CALIFORNIA COASTAL COMMISSION

STAFF REPORT: APPEAL
SUBSTANTIAL ISSUE

APPEAL NUMBER: A-5-LGB-02-265

PROJECT LOCATION: 31501 Bluff Drive, Laguna Beach, Orange County

LCP Access Map
 Figure 5
 COASTAL COMMISSION
 A-5-LG-B-02-265

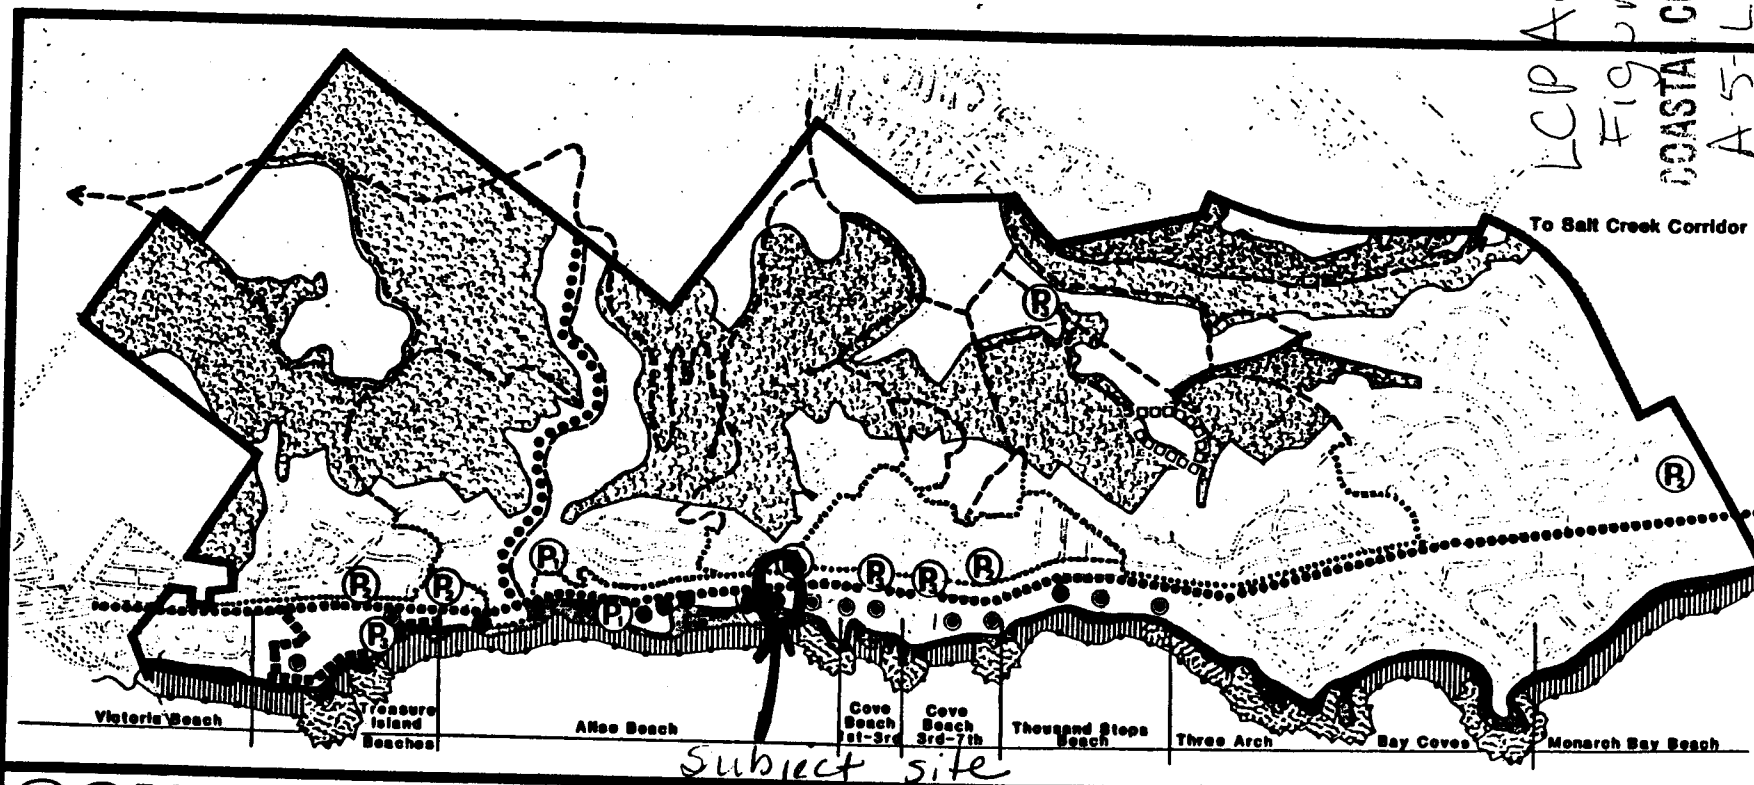
The private development approved by the City within the easement is located within a developed and operating accessway that is identified on Figure 5 of the City's certified LCP. Policy 3-L requires that public access be provided as identified on Figure 5 of the LCP. The City's approval of local coastal development permit 02-23 does not assure that the public will continue to be able to use the existing accessway as required by Policy 3-L due to the extremely close proximity of the private residential development to the easement and due to the private fence, landscape and roof overhang encroachments. Thus the development

The private development which the City approved within the easement is located within an accessway that is identified on Figure 5 of the City's certified LCP. Policy 3-L requires that public access be provided as identified on Figure 5 of the LCP. The city's approval of local coastal development permit 02-23 does not assure that the public will continue to be able to use the existing accessway as required by Policy 3-L due to the residential and private landscape encroachments. Therefore the development as approved by the City is inconsistent with Policy 3-L of the City's certified LCP.

Project
Site
Plan

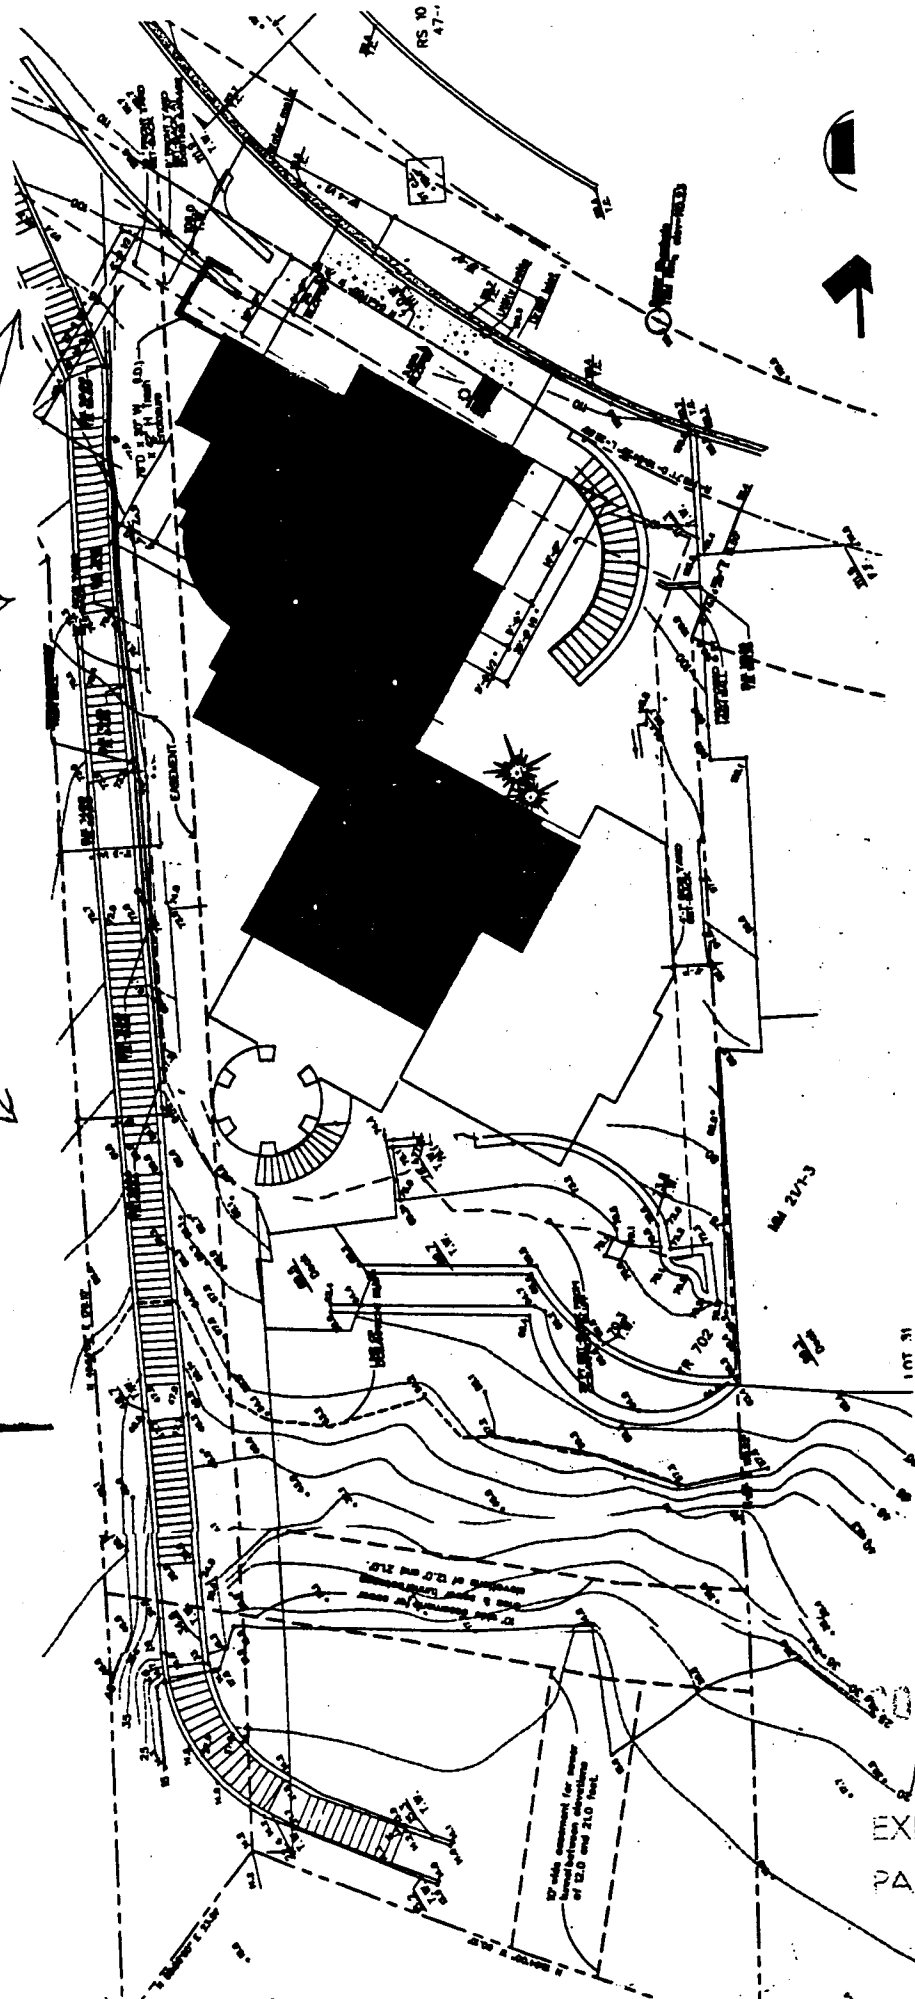
Local coastal development permit 02-23 includes approval of a new single family residence and landscaping. Although not identified in the City's public hearing notice or the notice of Final Action, portions of the approved development would occur within the public access easement held by the County of Orange. Development approved by the City within the easement includes roof overhangs and private landscaping.

A fence currently exists within the public access easement. The fence appears to be decades old. The existing fence runs almost the entire length of the easement. The entire fence encroaches into the County's public access easement. The amount of encroachment varies from approximately 4' (at the Coast Highway end) to approximately 7' (at the ocean end). Removal of the fence was not part of the City's approval of the project. Nevertheless the City planner assigned to the project indicated to Commission staff that the fence will be reconstructed in its current location. Although not described as part of the approved project, replacement of the fence seems likely given its age and deteriorated state. It is unlikely that the fence would simply be removed without being replaced as it serves as the separation between the public access stairway and the residence. In this case, the existing fence has created the boundary, though erroneously located, between public and private use. When the fence is reconstructed, which its current state dictates will be in the near future, it should be relocated out of the public access easement onto private land. In its current location it physically limits the area available to the public, thus minimizing public access. The City's approval did not include any special conditions regarding relocating the fence out of the easement at such time as the fence is proposed to be replaced or significantly altered. A special condition assuring that the existing fence encroachment will not be allowed to continue to diminish public access at the site is necessary to find the project consistent with the public access policies of the certified LCP and Coastal Act. Without such a special condition this

Project Landscape Plan

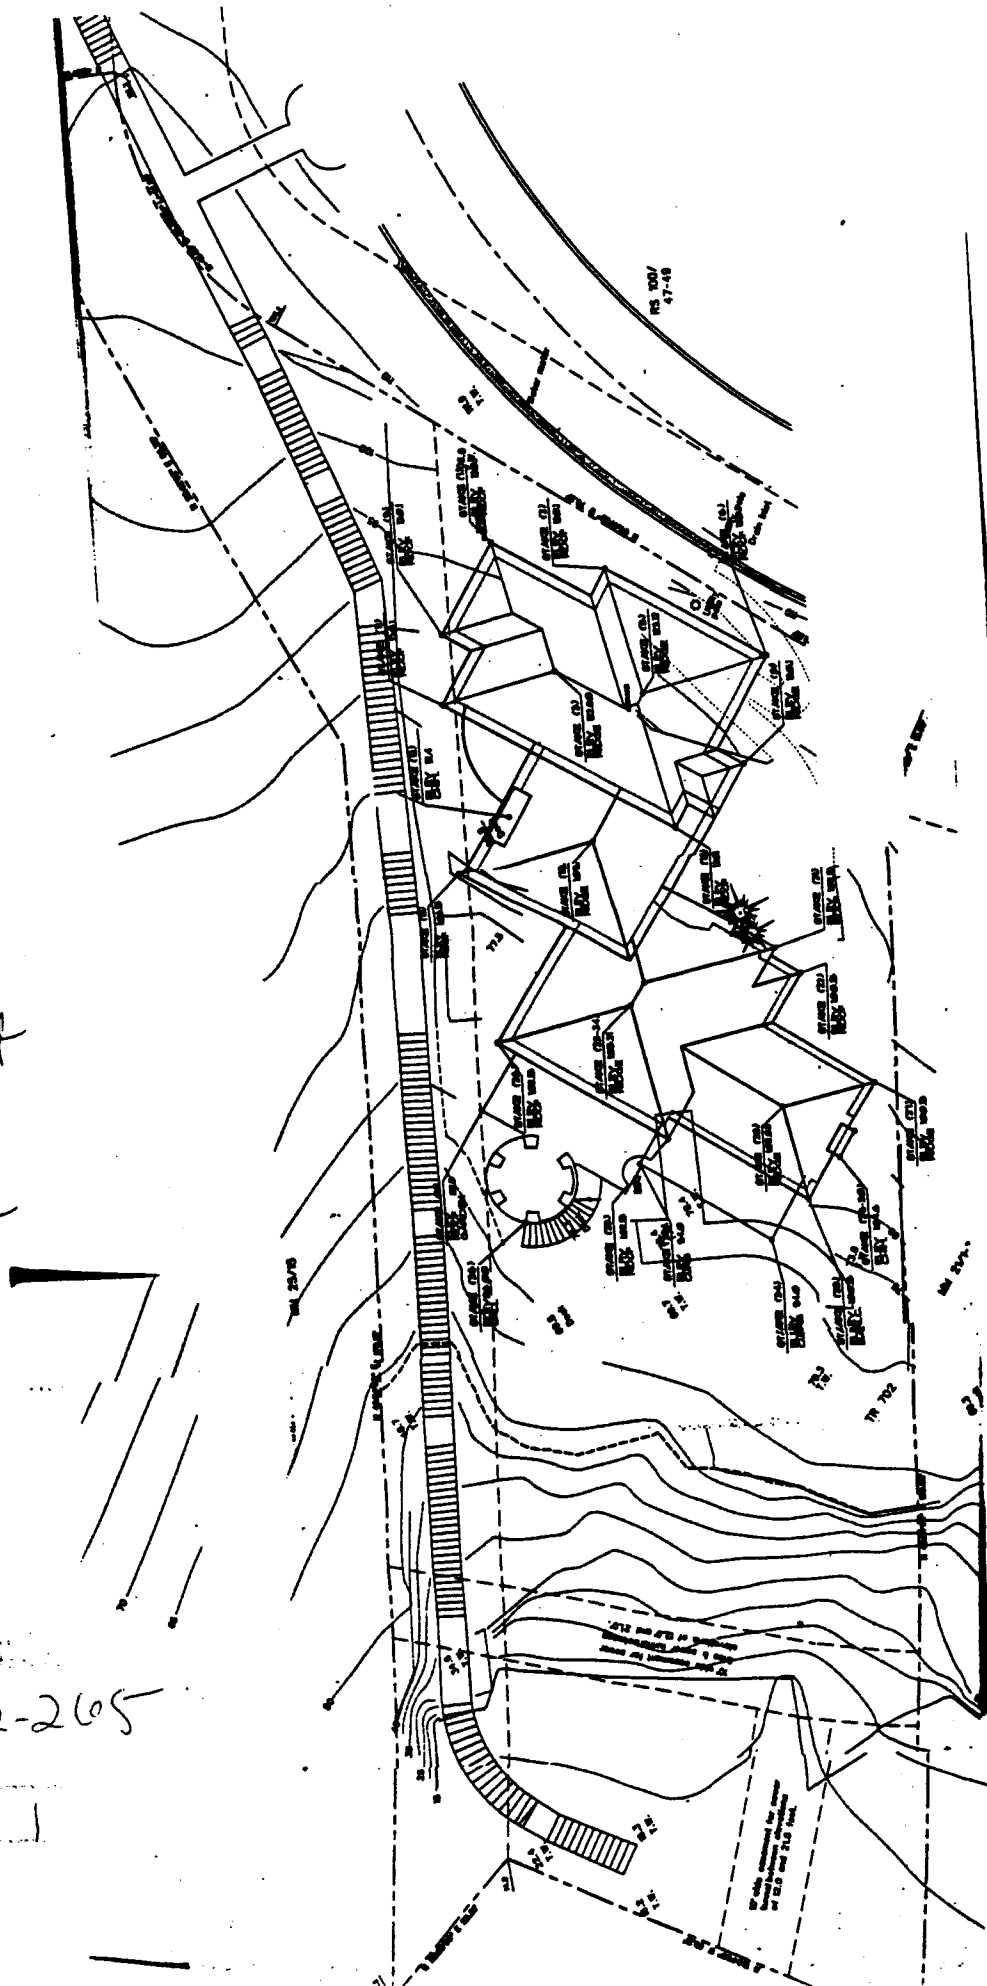
Private development within a public access easement, such as that described above, is inconsistent with the public access policies of the City's certified Local Coastal Program and of the Coastal Act. The development approved by the City within the easement adversely impacts public access by physically limiting the area available to the general public within the public access way. In addition, as private residential development is allowed within the easement to be closer to the existing public access stairway, the possibility increases that the accessway may appear to be private to the general public. The appearance that the access way may be private is further compounded by allowing private landscaping throughout the public access easement. The landscape plan approved by the City includes retention of existing landscaping in the easement area as well as substantial supplemental planting within and immediately adjacent to the easement.
